## SKEP III Home Office Support Site Visit Report

Consultant	Wahib Medanat Consultant Engineer	Rep No.	12-14092021
Contractor	Derar Saraireh & Sons for Engineering & Contracting	Tender No.	(11/2019/USAID/SKEP/3/S) Schools for a Knowledge Economy Project (SKEP) - Phase (3) Package (1, 2)
Site Name	Al Khansa' Basic Mixed School- Al Balqa	Day/ Date	Tue. 14/09/2021
Duration of Project	450 Calendar Days	Total Project Budget	9,789,417.840 JD

(Figure: 12)

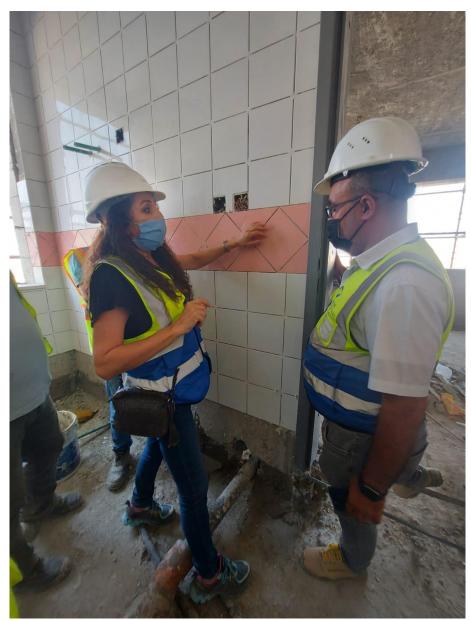
the ending of tiling at the limit of steel door frame was discussed and the supervision team stressed that the tiles end should be straight and neat without any gaps. The Contractor shall avoid installing electrical sockets within the colored tile strip
